**Flood Control Project Maintenance
Levee Inspections**

Maintenance Issue Types Only, Levee Inspection Report By Mile - Fall 2019

Reclamation District No. 0536 Egbert

Waterway	Bank	Unit Miles	Inspection Start/End	Inspector
Unit No. 01 Lindsey Slough	Right	5.58	10/25/2019 10/25/2019	David Julian

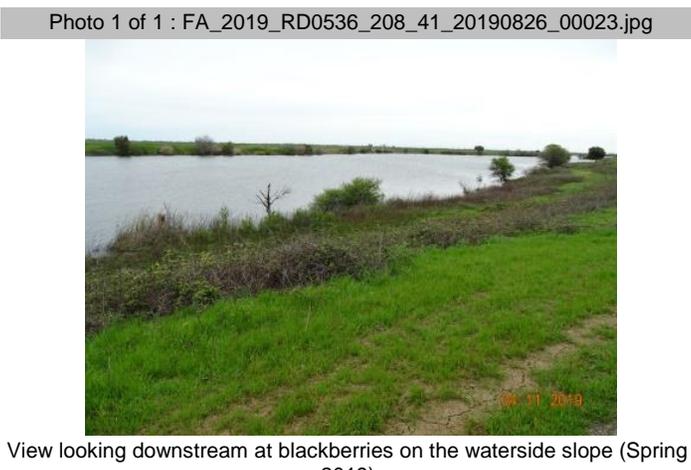
LM Start	3.96	Rating **	U	Issue No.	45
LM End	4.07	Issue Type +	Ma	Location *	LS
Category	Earthen Levee		GPS Latitude/Longitude		
			Start	End	
Item	Vegetation		38.250618°	38.250302°	
			-121.722550°	-121.720585°	
DWR ID	DWR_RD0536_01_f_2019_45				
Comment Code					
V1 : Control annual grass and weeds on the levee slopes and easements.					
Inspector Comment

LM Start	3.98	Rating **	M	Issue No.	41
LM End	3.98	Issue Type +	Ma	Location *	WS
Category	Earthen Levee		GPS Latitude/Longitude		
			Start	End	
Item	Vegetation		38.250514°	38.250514°	
			-121.722303°	-121.722303°	
DWR ID	DWR_RD0536_01_s_2019_41				
Comment Code					
V2 : Remove the wild growth other than native grasses from the levee slopes.					
Inspector Comment					
Remove blackberries at least 20' from waterside shoulder.

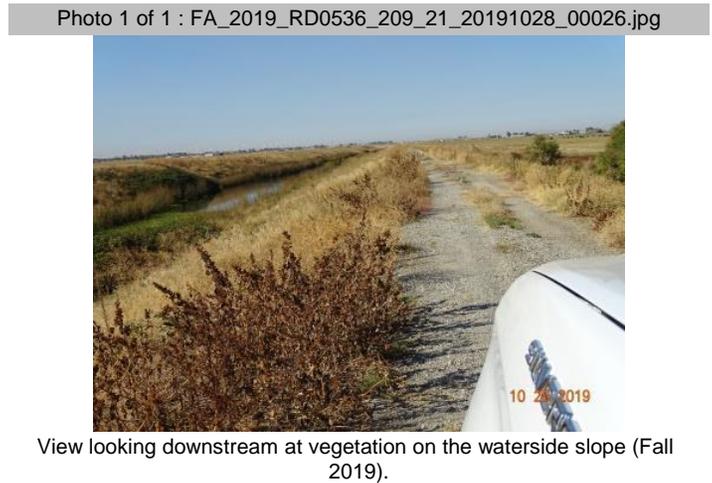
LM Start	3.51	Rating **	M	Issue No.	21
LM End	4.48	Issue Type +	Ma	Location *	WS
Category	Earthen Levee		GPS Latitude/Longitude		
			Start	End	
Item	Vegetation		38.197145°	38.197076°	
			-121.683912°	-121.701006°	
DWR ID	DWR_RD0536_02_f_2019_21				
Comment Code					
V1 : Control annual grass and weeds on the levee slopes and easements.					
Inspector Comment

LM Start	3.51	Rating **	U	Issue No.	16
LM End	4.99	Issue Type +	Ma	Location *	LS
Category	Earthen Levee		GPS Latitude/Longitude		
			Start	End	
Item	Vegetation		38.197145°	38.198770°	
			-121.683912°	-121.710077°	
DWR ID	DWR_RD0536_02_f_2019_16				
Comment Code					
V1 : Control annual grass and weeds on the levee slopes and easements.					
Inspector Comment
